# Meeting with US NRC

## Discuss Clarifications of NRC RAIs/Observations on NEI 22-01, Revision 1

July 2, 2025

# RAI 3 Sorption Coefficient ( $K_d$ ) Estimates (3/12)

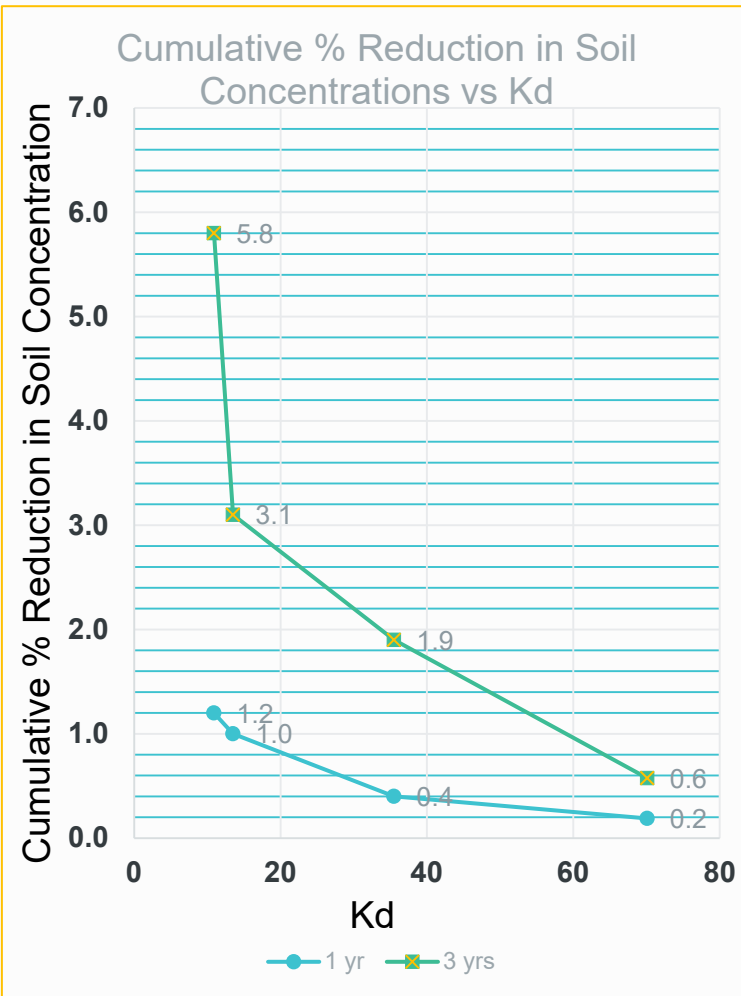
- RAI Summary - Clarify in the NEI 22-01 guidance that measurements of sorption coefficients are not required at sites based on NRC's guidance in DUWP-ISG-02. Further discussions between NEI and the NRC staff are warranted on what is meant by site-dependent information and representativeness of site information to the appropriate media (e.g., contaminated zone or groundwater flow pathways).
- NEI Reply – NEI will add discussion to NEI 22-01 concerning  $K_d$  from DUWP-ISG-02, Section 3.3.2, *Determining if a Parameter Value is Risk-Significant*. The following slides summarize these additions.

- Proposed discussion in NEI 22-01, Significant Radionuclides (Cont.): DUWP-ISG-002, Table 3.6 provides a list of radionuclides including some characterized as having a relatively high uncertainty in defining the values for  $K_d$  and/or for which a site-specific study is recommended. NEI has performed a review of experiences at US nuclear plants including the LTPs of five plant sites that used RESRAD with the resident farmer scenario to determine DCGLs for soil. The following are the results that review for the subset of radionuclides discussed in DWUP-ISG-002 concerning:
  - Concentrations of these radionuclides in soil and groundwater
  - Results of sensitivity analysis for radionuclides measured in significant quantities
